Date 13.06.03	Ref. No. <b>03AH003</b>	Model <b>AM-LM918, LCX-MT22, XR-FD1, XR-FD5, XR-V10MD</b>	HA
Subject <b>"Disc Error" Indication</b>			IRIS C625

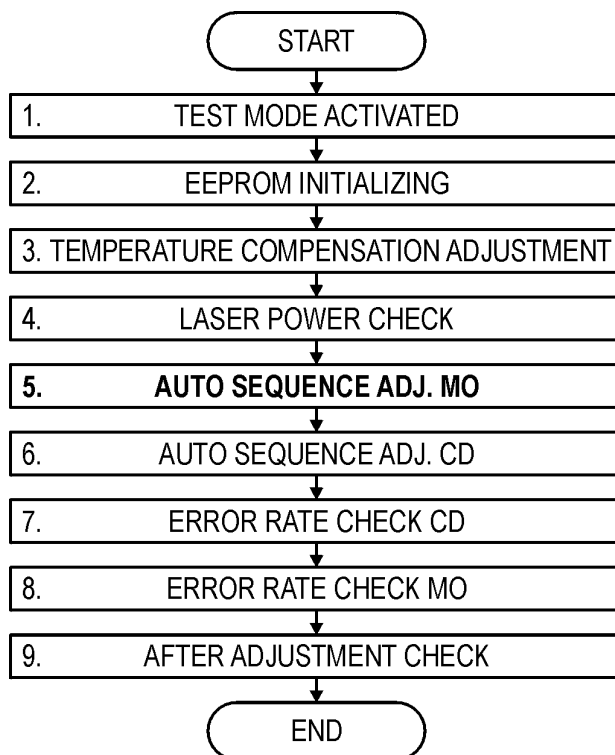
"Disc Error" may be displayed with specific discs such as Sony MD (Neige series), i.e. 5MD74NEA, 5MD80NEA, 10MD74NEA, 10MD80NEA.

Unstable reading when using low-reflectivity MO discs.

Using the test disc **"MDW-74/AU1" (8-892-341-41)**, only perform the "Auto Sequence Adj. MO" (step 5 of the "Adjustment Procedure Flowchart" below).

If the message "Failed" appears during the adjustment, perform the complete adjustment procedure as described in the Service Manual.
